**MASSACHUSETTS STATE BUILDING CODE**

**By Seismic Design Advisory Committee of the Boston Society of  
Civil Engineers Section/American Society of Civil Engineers**

INTRODUCTION

Figure 716.1

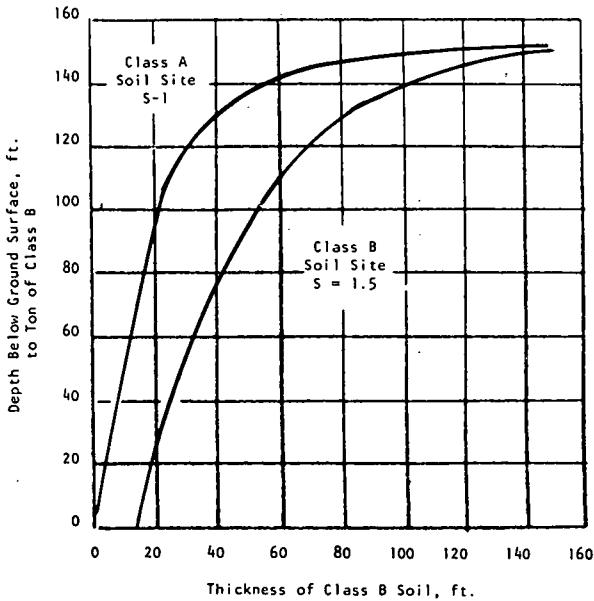
3. Section 716.4.1, Item 3, including Fig. 716.1

3. S factor: For a Class A soil site,  $S = 1$ . For a Class B soil site,  $S = 1.5$ . Intermediate values of S may be used as justified on the basis of Figure 716.1 or by the results of adequate studies by a registered professional engineer. The value of CS need not exceed zero point twelve (0.12). (See Section 720.5 for definition of Class A soil.)

(Figure 716.1 is deleted.)

3. S factor. The S factor shall have the following values according to the types of soil sites as defined in Section 720.5:

Soil Site S1,  $S = 1$

Soil Site S2,  $S = 1.2$

Soil Site S3,  $S = 1.5$

Values other than those tabulated may be used provided they are based on studies by a registered professional engineer and are not less than 1.0.

Fig 716.2 DESIGN RESPONSE SPECTRUM

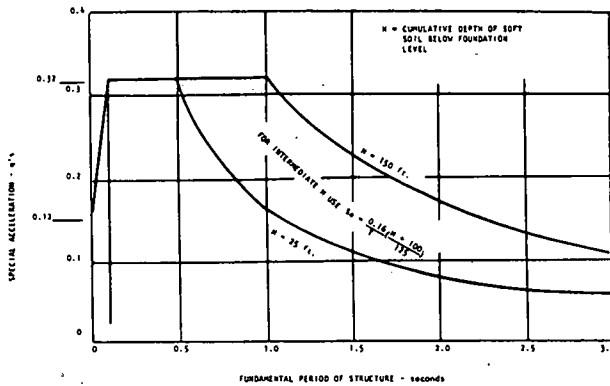
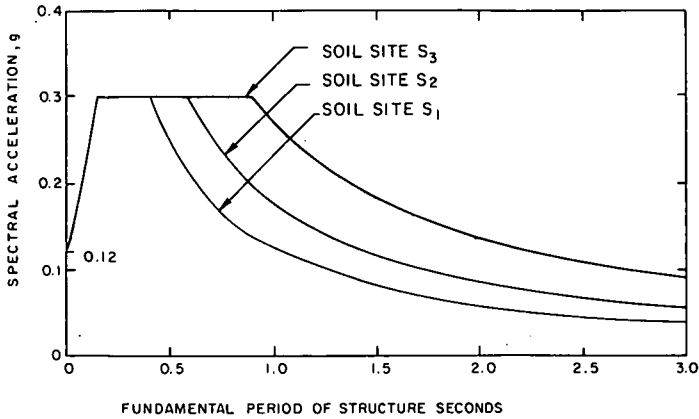
4. Section 716.7, Fig. 716.2 .

In the proposed revisions, three categories of sites are defined, based upon both the quality and the depth of the soils that are presented. In Section 716.4.1, a numerical soil factor is assigned to each category. In Fig. 716.2 of Section 716.7, there are curves corresponding to each category. The soil factors are intended to provide for the effect of local soil conditions upon the amplitude and frequency content of ground motions. They also cover other possible adverse effects of poorer soils. For example, greater strength is desirable in buildings founded over ground that may experience differential settlement during an earthquake.

The soil factors range from 1 to 1.5 for the lateral force equation and for 1 to 2 for the response spectrum. Since the response spectrum refers basically to elastic behavior, an increase in lateral forces of up to a factor of 2 appears reasonable, particularly for soft ground and long period buildings. The lateral force equation refers to elasto-plastic behavior of ductile structures for which the increase in lateral force would be smaller than elastic behavior, and thus a maximum factor of 1.5 is appropriate.

The soil factors for the lateral force equation apply over the entire range of building periods. In the response spectrum there is no increase in lateral force for soft ground if the building

period is less than 0.5 sec. The elastic-plastic behavior assumed for the lateral force method will result in an increase of the building period during the earthquake and thus even for buildings with a small initial or elastic period, one should increase the lateral force for cases with soft ground. This is not necessary if the analysis is elastic.

Interpolation between soil factors, or between the curves of Fig. 716.2, is permitted. However, it must be recognized that precision in the choice of soil factors is very seldom warranted and use of interpolation is not encouraged.

Fig. 720.1- LIQUEFACTION POTENTIAL OF CLEAN FINE TO MEDIUM SANDS

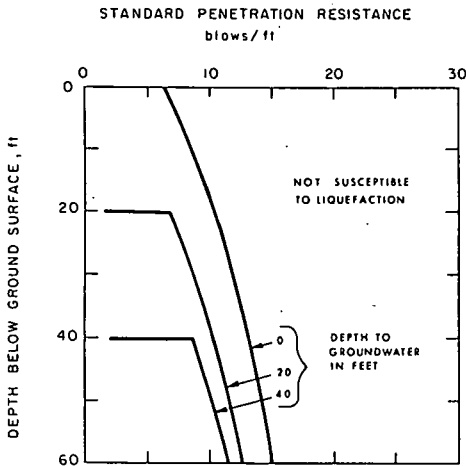
SECTION REQUIRING CHANGE: 720.4, Fig. 720.1

The Massachusetts Building Code contains provisions for evaluating the liquefaction potential of saturated sands for the design seismic event. These provisions are contained in Section 720.4 and in Fig. 720.1, which are reproduced in the appendix to this commentary. A revision to Fig. 720.1 has been prepared by the Seismic Advisory Committee of BSCES/ASCE. The purpose of this commentary is to present the background for the liquefaction regulations, the reasons behind the proposed change, and comments on its proper use.

The blowcount criteria presently in the Code were based on the upper bound curve in Castro, 1975, Fig. 1, for a peak ground surface acceleration of 0.12g, in agreement with the design response spectra in Fig. 716.2 of the Code. The criteria in Castro 1975 does not discriminate among earthquakes of different magnitudes; however, the position of the upper bound curve is strongly influenced by data from the magnitude 7.5 Niigata earthquake. More recent studies, e.g., Seed, 1983, have led to upper bound curves which are a function of earthquake magnitude. The proposed revision to the present blowcount criteria is based on the data in Fig. 2 taken from Seed et al., 1983 where the earthquake data is plotted using the following coordinates:

The upper bound line in Fig. 2 was used to develop the proposed revised criteria assuming a maximum ground surface acceleration of 0.12g and an earthquake magnitude of 6.5. The proposed revised criteria are compared with those presently in the Code in Fig. 4.

If all blowcounts for sands below the groundwater level lie above the boundary lines in Fig. 2, no further consideration of liquefaction is indicated. Often, however, one finds sites for which some of the blowcounts fall below the line. Whether in such a case further consideration of liquefaction is required would depend on the judgment of a geotechnical engineer based on the following factors:

The criteria in Fig. 2 are applicable to saturated clean (less than 12% fines) sands. Generally for silty sands the criteria in Fig. 2 are conservative; however, in our opinion, there are not, as yet, sufficient data on these soils to develop blowcount criteria applicable to silty sands and suitable for a Code regulation. Clayey sands or any soils exhibiting some plasticity
